Subject: Revision of Licensing Topical Report, NEDO-11209, Nuclear  
Energy Business Group BWR Quality Assurance Program  
Description

Enclosed for your review are four copies of Revision 2 to the General Electric Licensing Topical Report, "Nuclear Energy Business Group BWR Quality Assurance Program Description," NEDO-11209-04A. This revision primarily affects sections 1 and 2 of the text of NEDO-11209-04A and will also result in minor changes in the pages entitled "Page Control Sheet" and "Abbreviations." The revisions to NEDO-11209-04A, Revision 1, encompass two basic categories of change:

Figure 1-1. Nuclear Energy Business Group

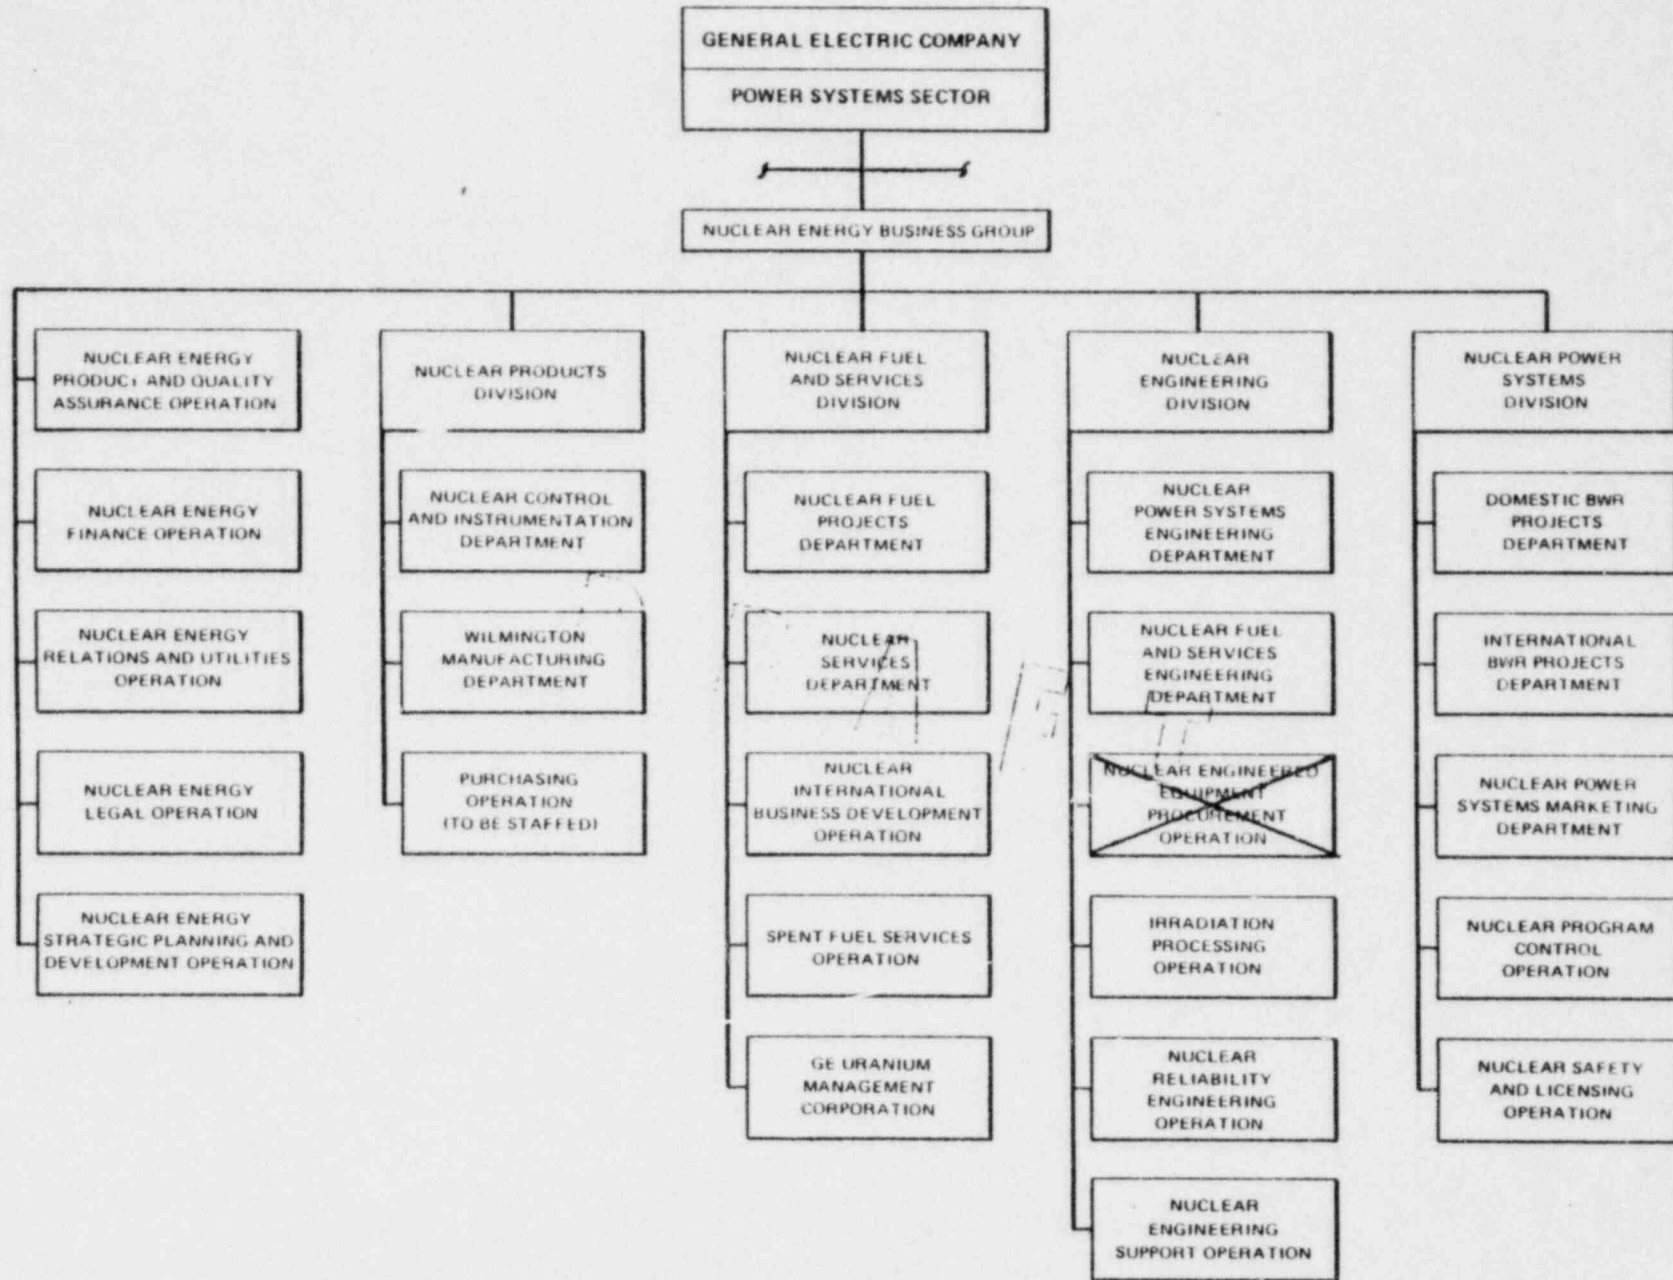
- ° The organizational changes identified in my letter to you dated August 6, 1980. These changes are identified on the attached draft figures 1-1, 1-2, 1-5, 1-6, and 1-8. Additional changes will be made in the text where necessary to correct organizational nomenclature to match the changes depicted in the attached draft figures (see Attachments 1 through 5).
- ° Alternate position change on USNRC Regulatory Guide 1.123, Rev. 1, July, 1977. Reference letter, W. P. Haass to A. Breed, "Proposed Change (control of nonconformances) to GE Topical Report NEDO-11209-04A," dated May 2, 1980. The attached alternate position on Regulatory Guide 1.123 is as discussed with you during our meeting in Norfolk, Virginia, on June 3, 1980, and subsequently confirmed (with two minor changes) in a telephone conversation between J. Conway (NRC) and D. G. Long (GE) on August 5, 1980 (see Attachment 6).
